Item ID: D212-664-101TRN

Item Name: Crosstube Turning Detail

DART AEROSPACE LTD	Work Order:	<i>91776</i>
Description: Crosstube Assembly (205/212/412 High Fwd)	Part Number:	D212-664-141
Inspection Dwg: D212-664-141 Rev: D		Page 1 of 2

DRAWING NO. D212-664-141	TITLE XTUBE ASSY (205/212/412 HI FWD)	REV. D	DART AEROSPACE LTD ENGINEERING ORDER		D.E.O. NO. D212-664-141-D-1	SHEET NO. SHEET 1 OF 2	SCALE NTS
DRAWN	CHECKED	MFG. APPR.	APPROVED	DE APPR.			
DATE 11.04.07	DATE 11.07.11	DATE 11.04.12	DATE 11/04/12	DATE 11.04.12

**D212-664-141/-141B
ASSEMBLY DETAIL**

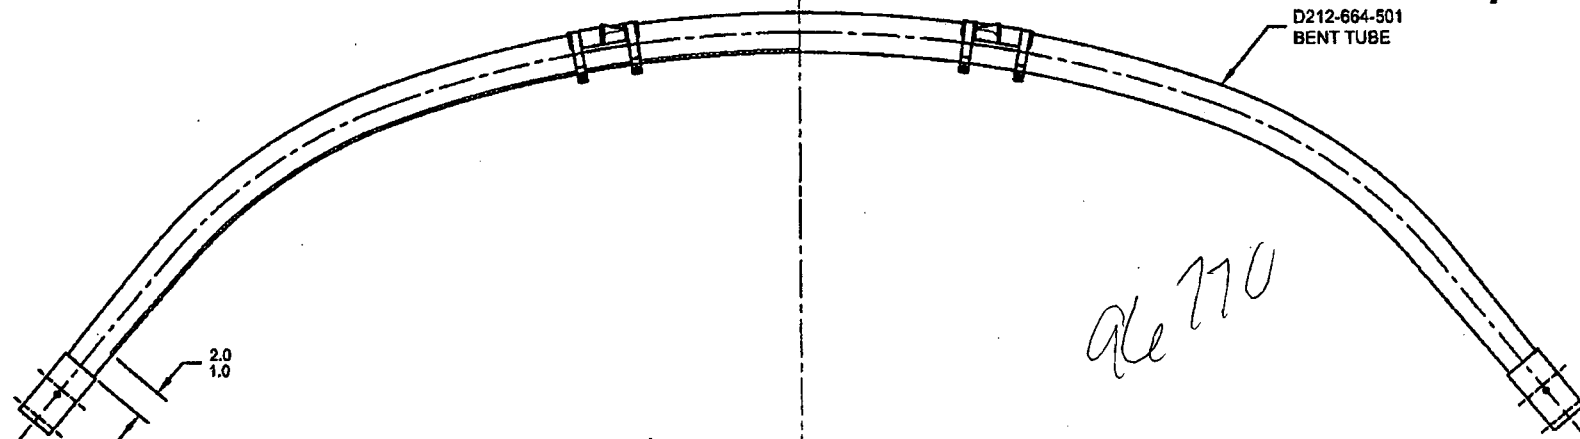
PURPOSE:

ADD AN INSPECTION WINDOW TO UNDERSIDE OF CROSSTUBE.

MASK AREA PRIOR TO PAINTING,
REMOVE MASKING AFTER PAINT
AND APPLY CLEAR COAT

NOTES 2 OF SHEET 1 IS AMENDED AS FOLLOWS:

- 2) FINISH: CHEMICAL CONVERSION COAT PER DART QSI 005 4.1
PRIME INSIDE AND OUTSIDE PER DART QSI 005 4.2
MASK UNDERSIDE OF CROSSTUBE AS SHOWN (HATCHED AREA) AND
PAINT OUTSIDE PER DART QSI 005 4.2
REMOVE MASKING AND APPLY CLEAR COAT
